ADDENDUM NUMBER ONE

Indiana University
Launch Accelerator for Biosciences
1302 Indiana Ave.
Indianapolis, IN 46202

Addendum Dated: OCT 16, 2025

IU Project #: 20250072
BSALS Project #: 00360481

C300

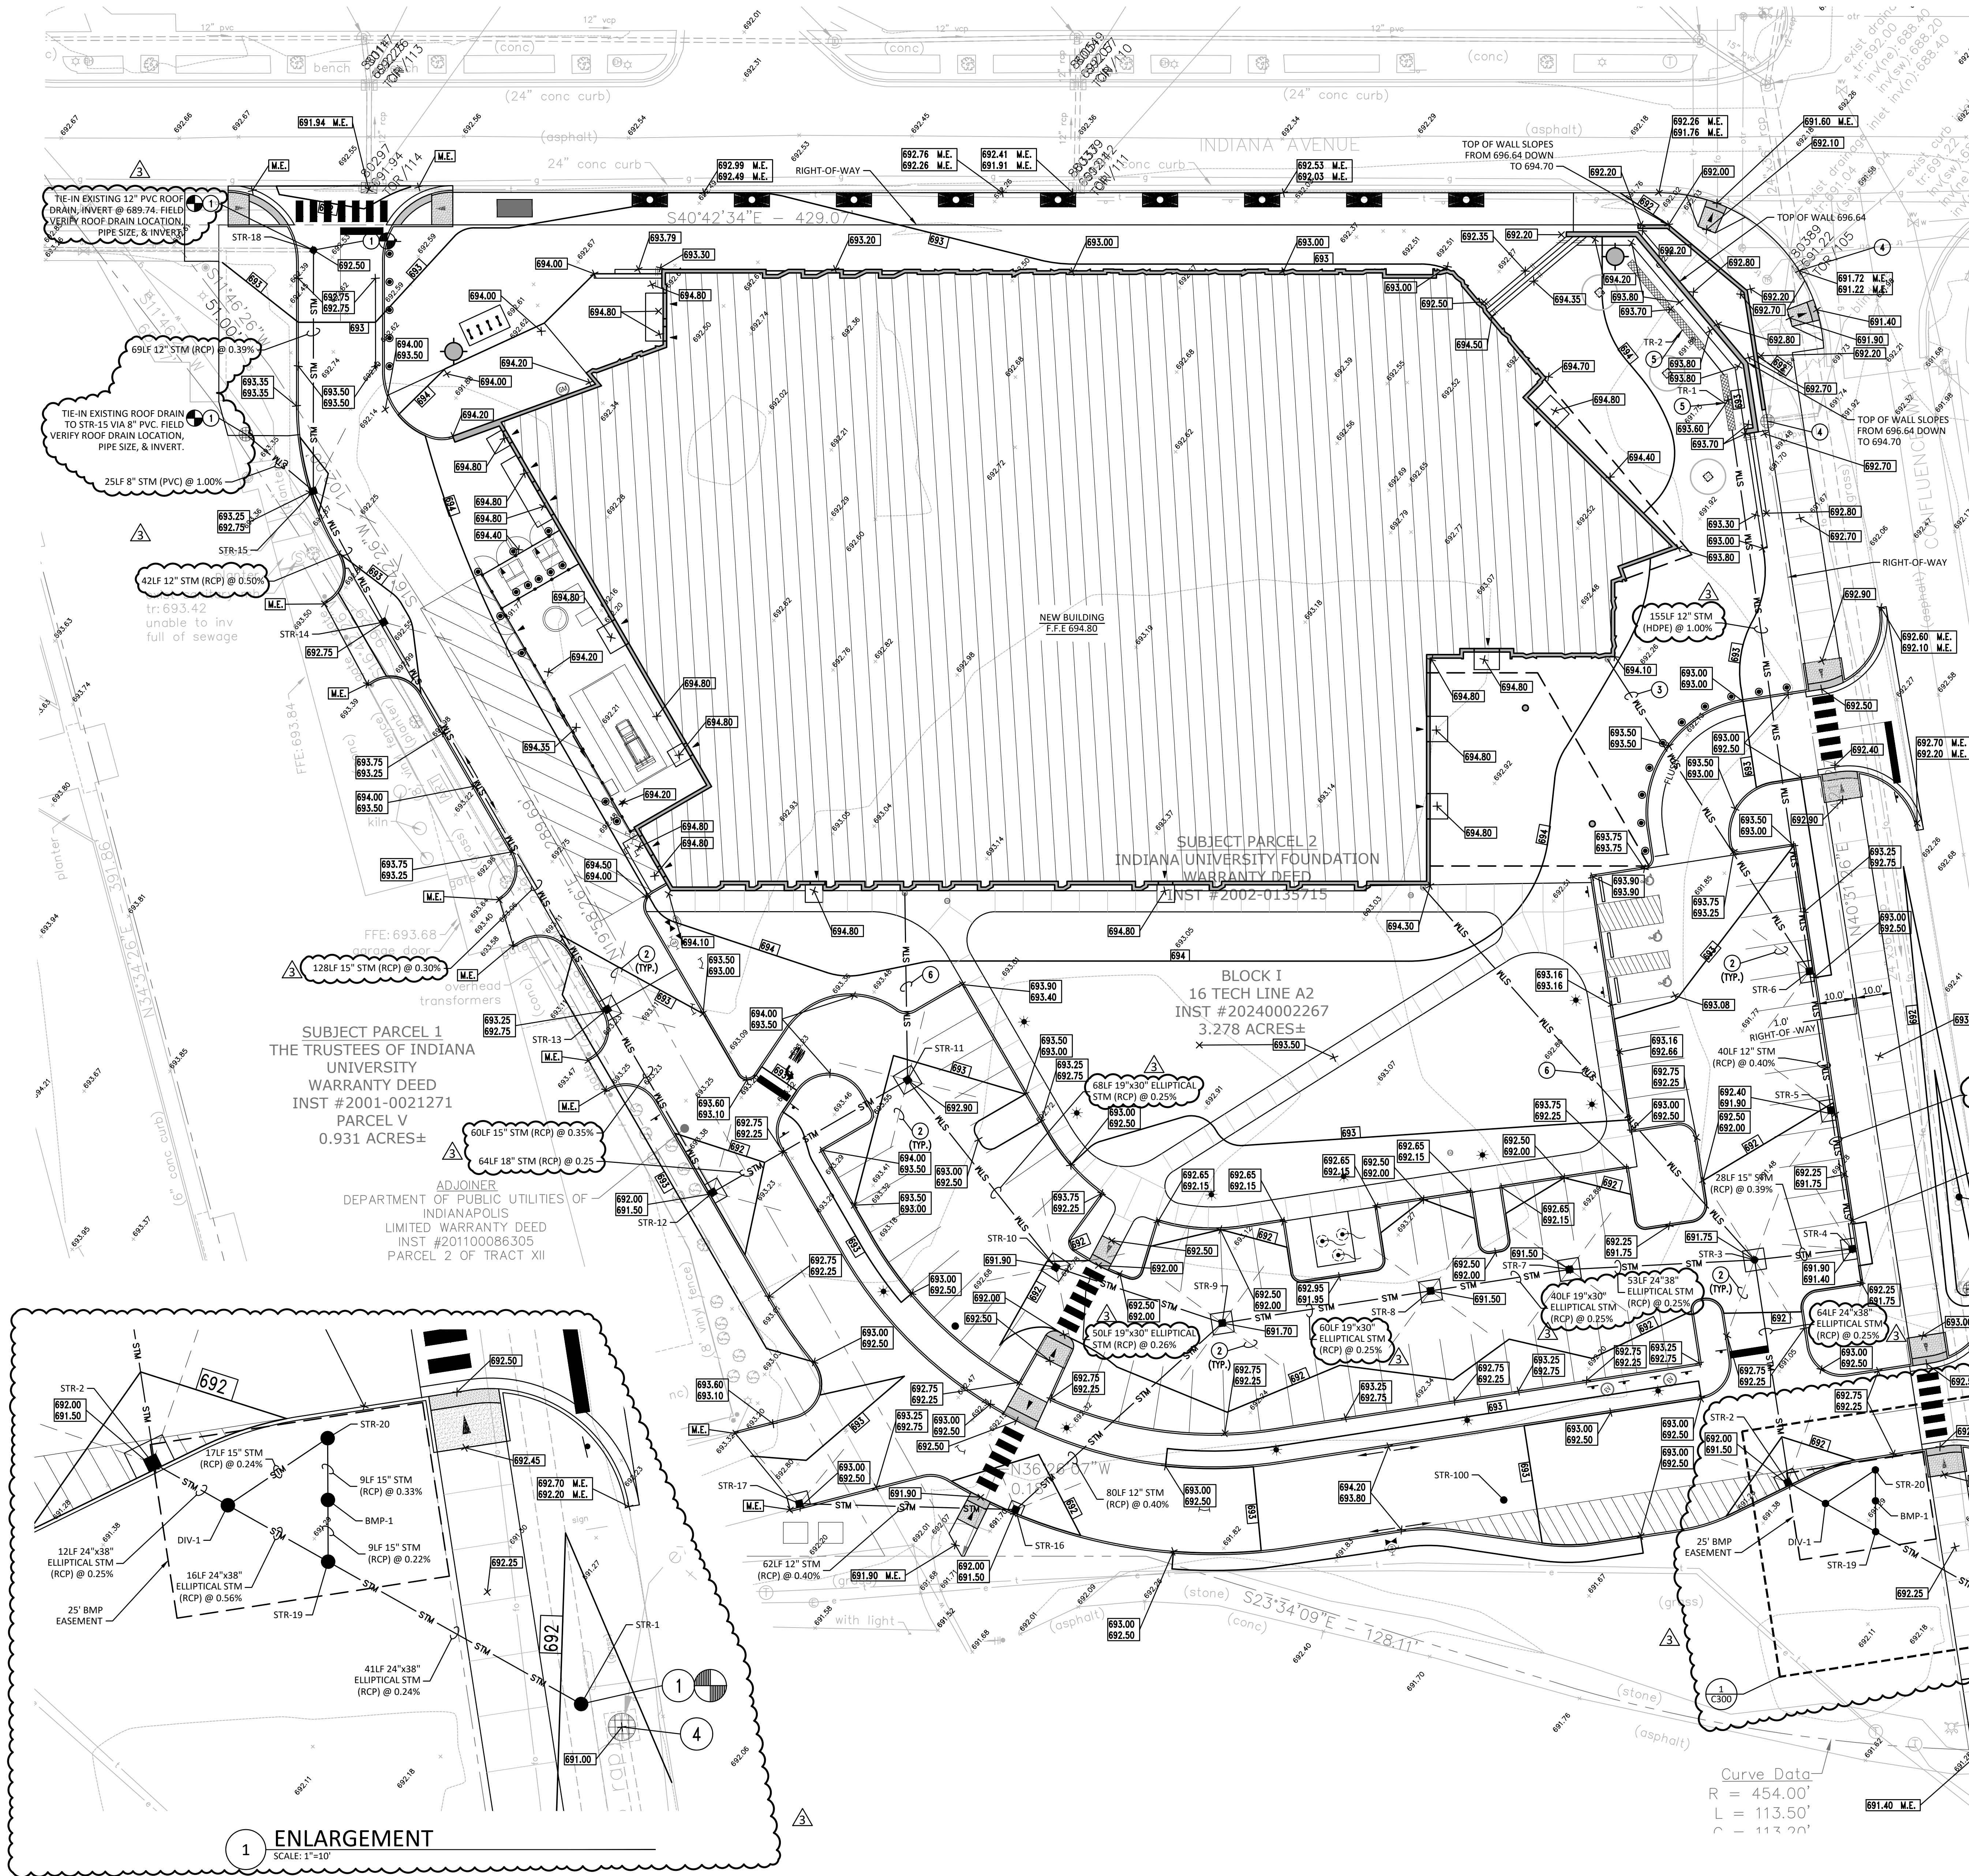
3. **Sheet C300:**
 - a. Revise the storm sewers as shown on the attached revised sheet C300.
4. **Sheet C310:**
 - a. Add diversion structure detail #13 as shown on the attached revised sheet C310.

C400

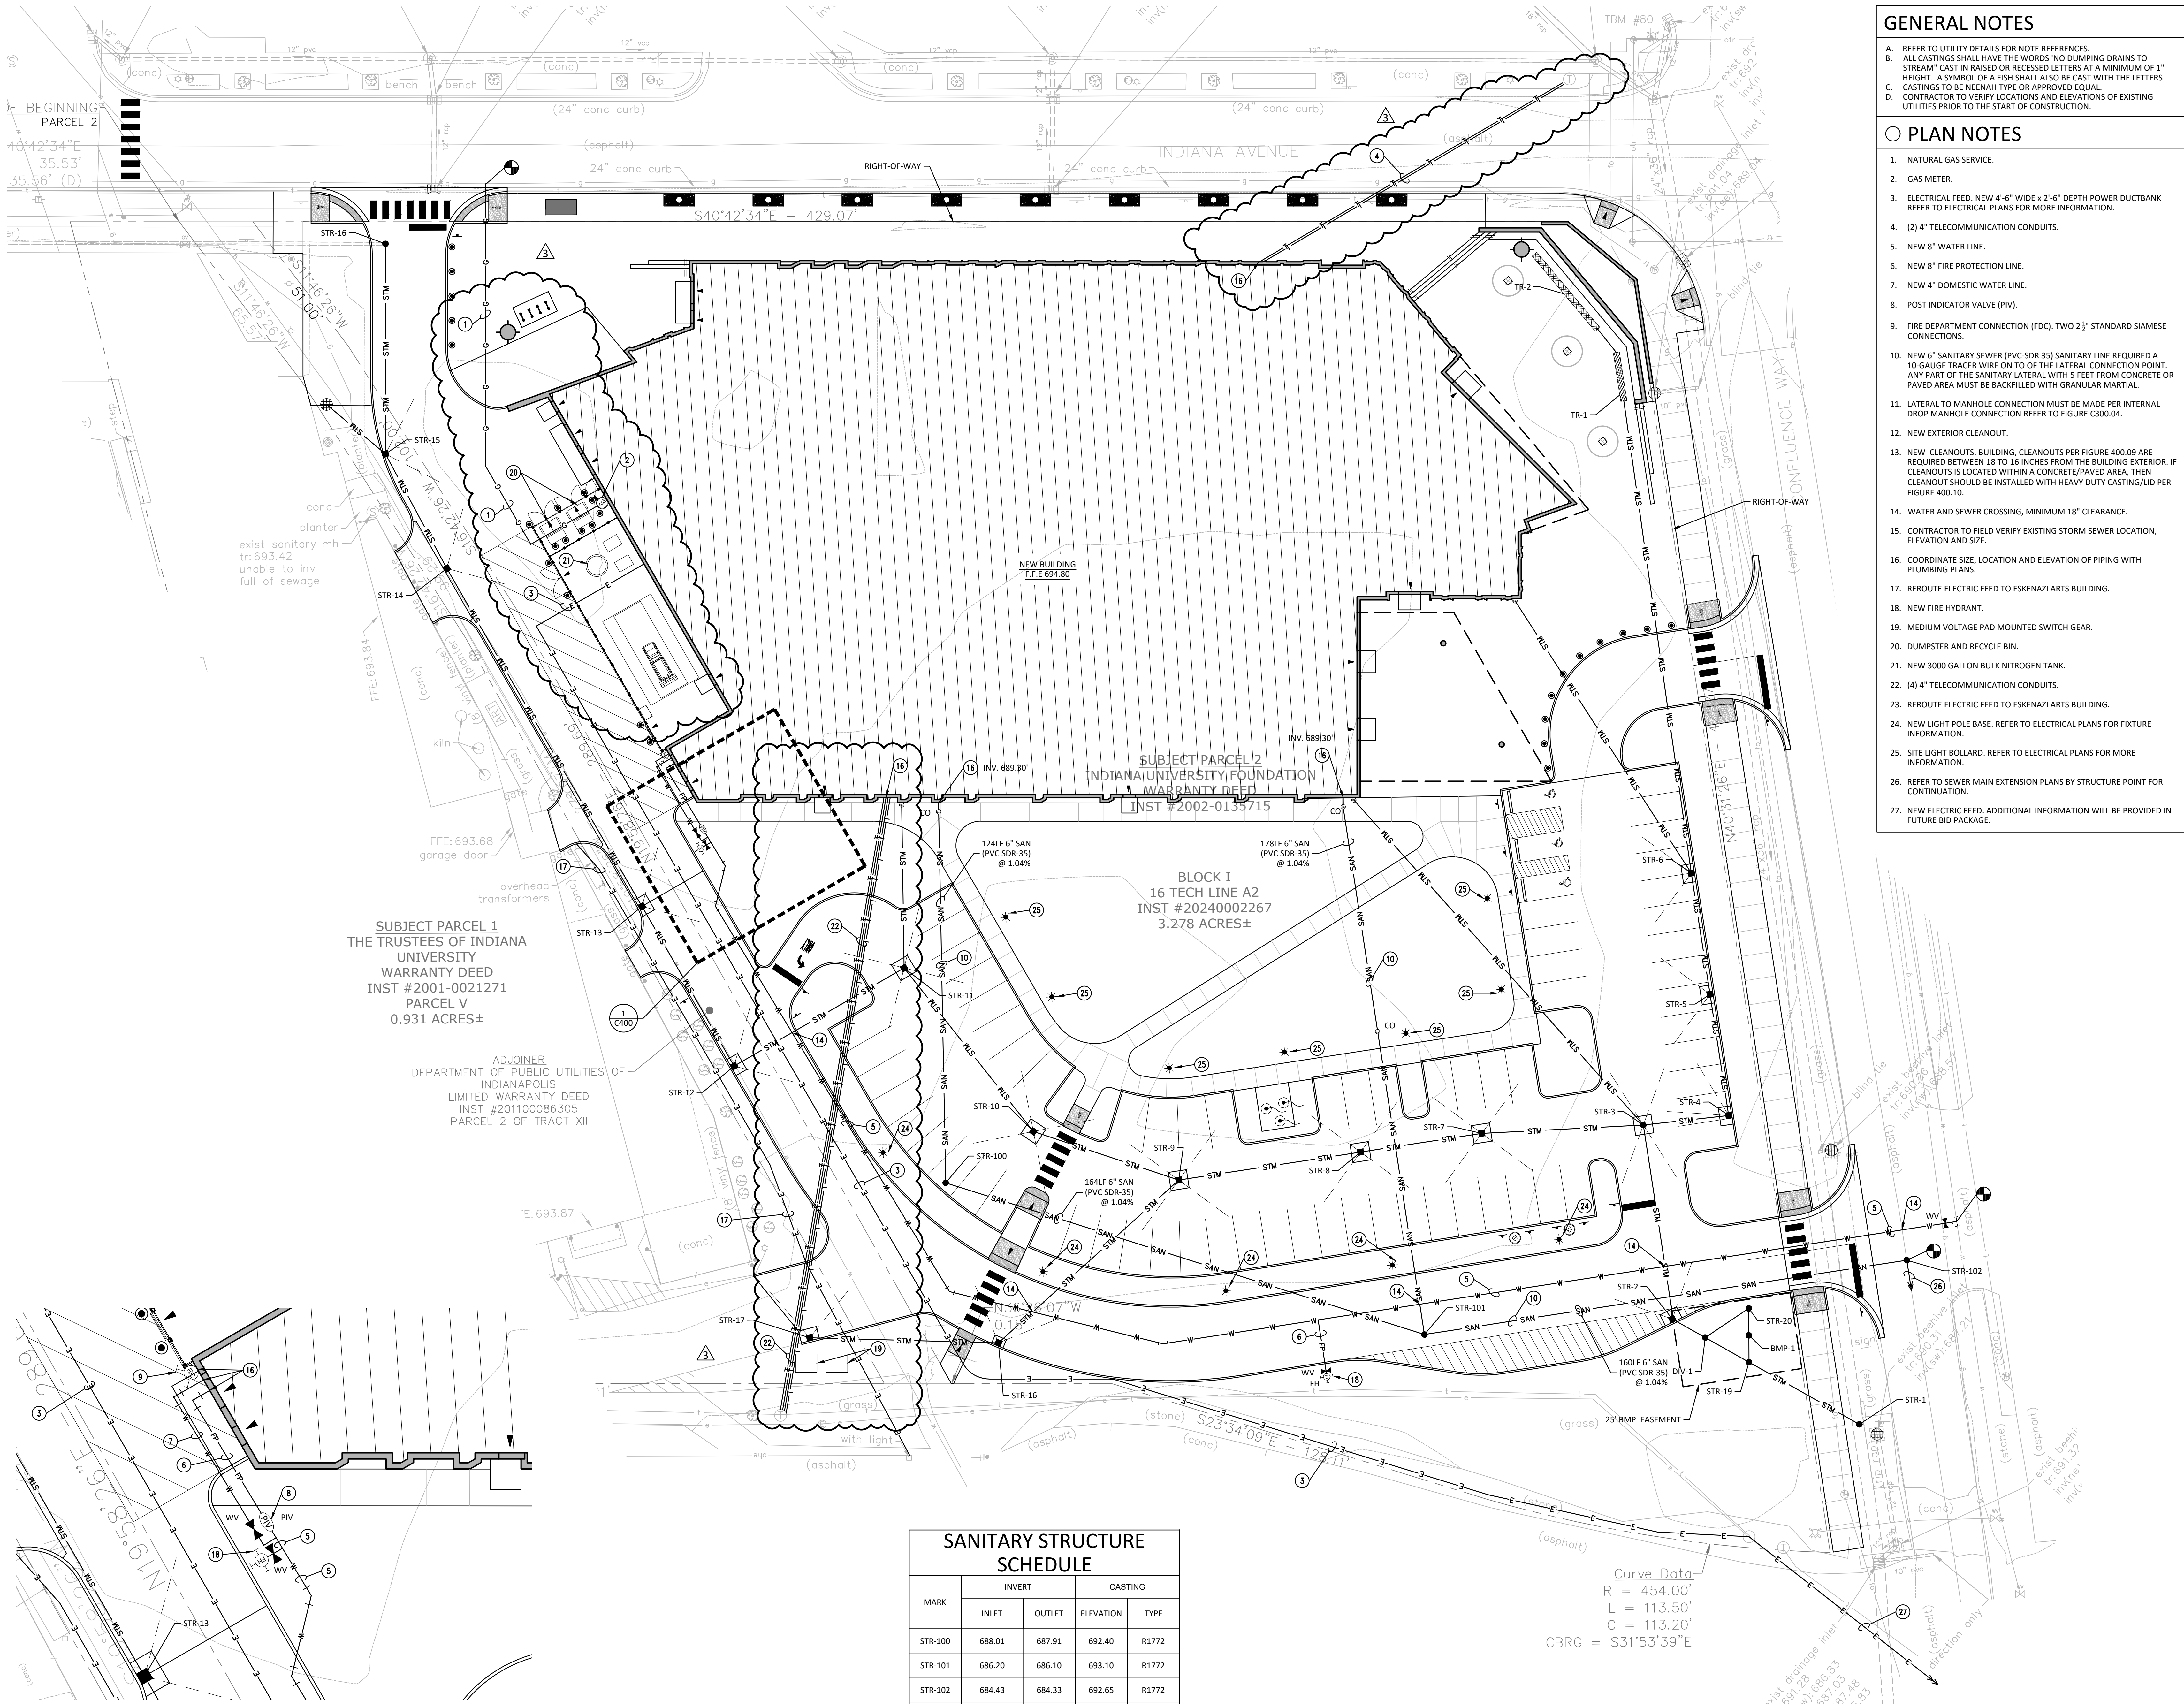
5. **Sheet C400:**
 - a. Revise telecommunication lines as shown on the attached revised sheet C400.
 - b. Revise the gas line route and meter location as shown on the attached revised sheet C400.

- c. Revise the MEP yard area layout as shown on the attached revised sheet C400.
 - d. Add the diversion structure and revise the BMP layout as shown on the attached revised sheet C400.

C420

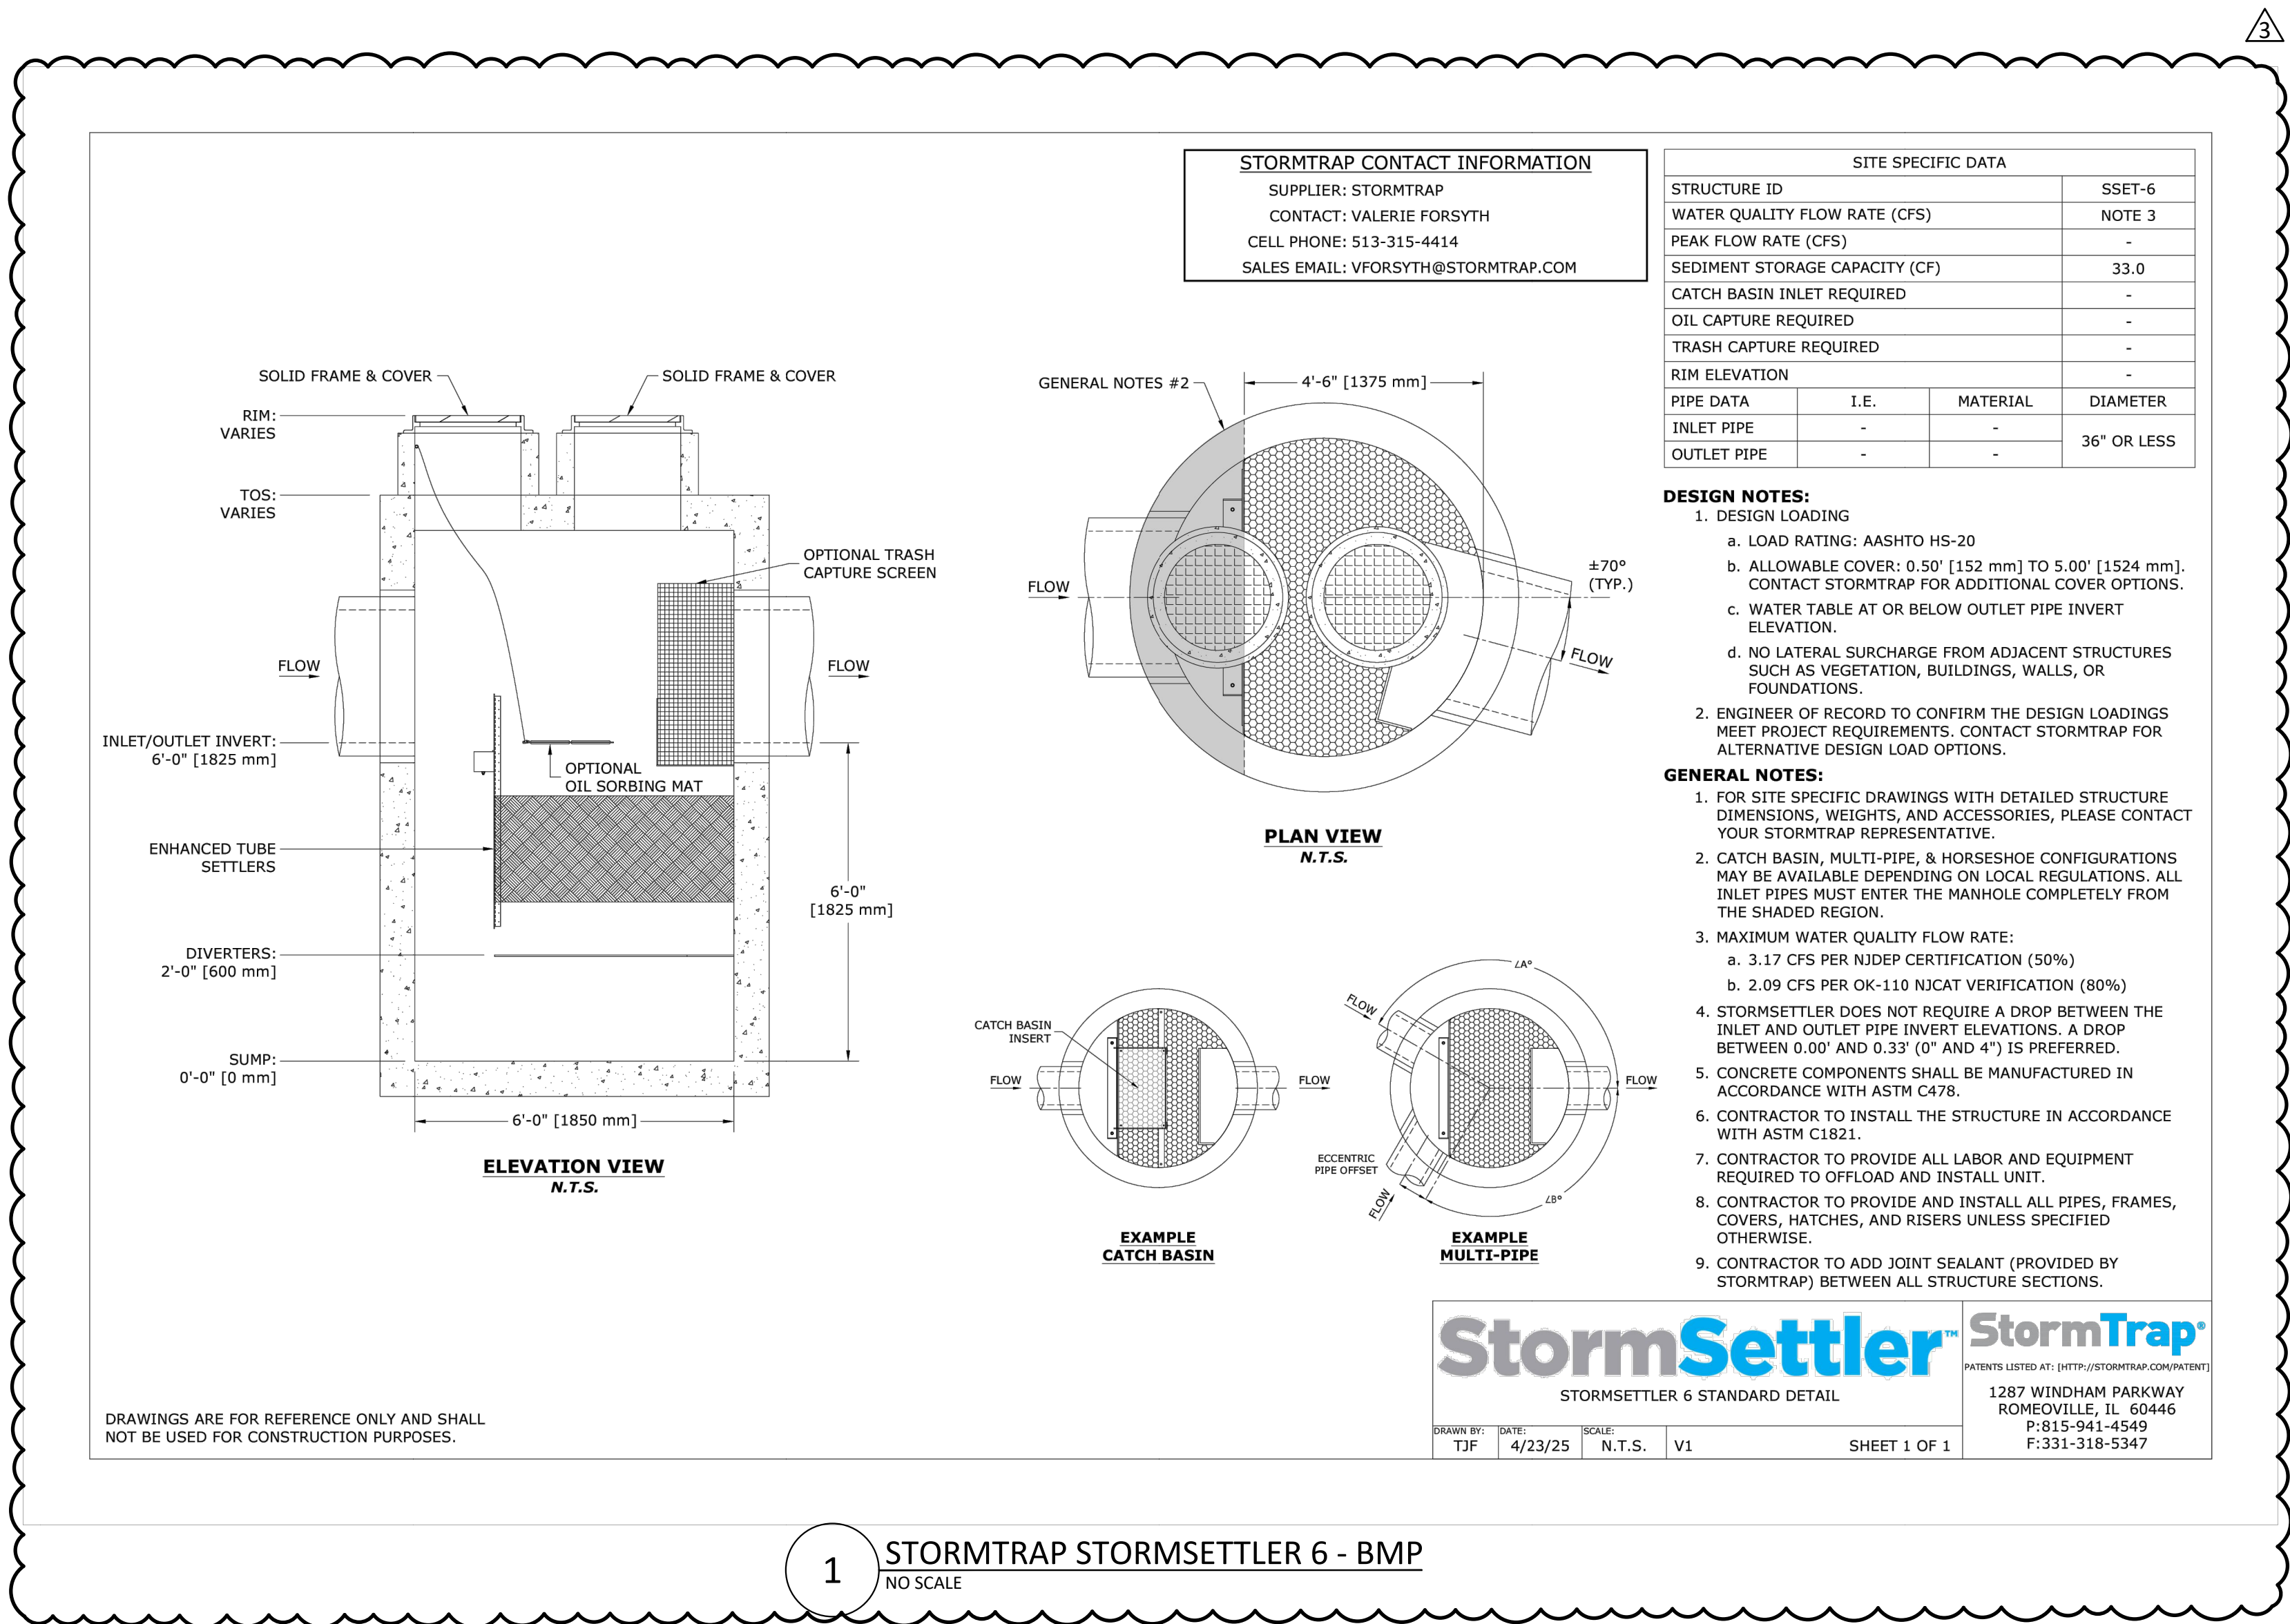
6. **Sheet C420:**
 - a. Revise the BMP detail as shown on the attached revised sheet C420.
7. **Sheet C500:**
 - a. Revise the MEP yard area layout as shown on the attached revised sheet C500.
